# PEER REVIEW OF SACRAMENTO VALLEY FINITE ELEMENT GROUNDWATER MODEL (SACFEM)

U.S. Bureau of Reclamation

Prepared by:  WRIME

October 2011

Figure 37. Proposed Calibration Wells

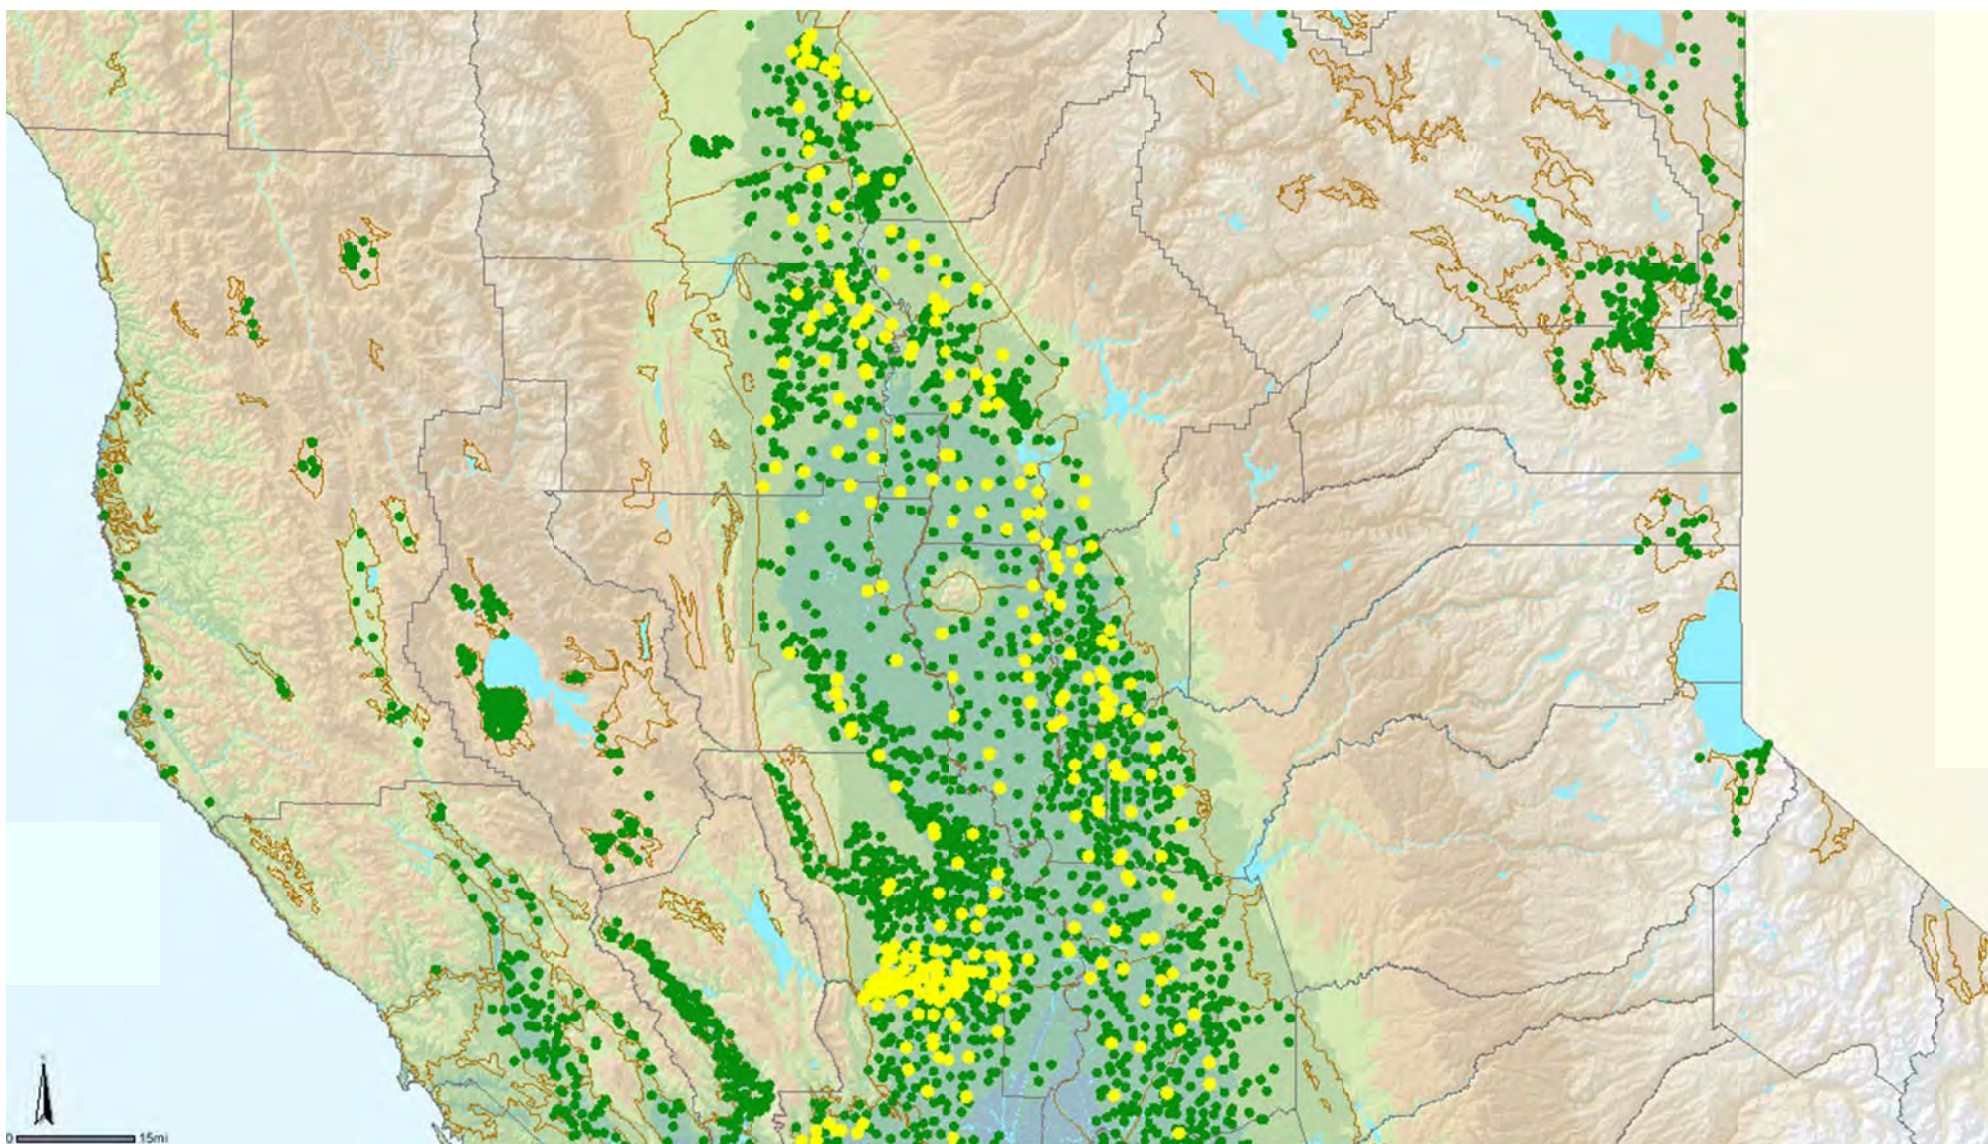
Groundwater elevation of these wells was reviewed and a set of 108 wells was selected, which could be added to the SacFEM calibration wells to improve the calibration quality of the model in western Placer, southern Sutter and Yuba Counties (Figure 37). These areas are of special interest as a significant number of SVWMP and 2009 Drought Water Bank projects wells are located in this area.

It is recommended to include additional calibration wells in SacFEM to improve its calibration quality. These wells could be used for re-calibration of SacFEM with a focus on the fine grid areas and areas with significant stream-aquifer interactions.
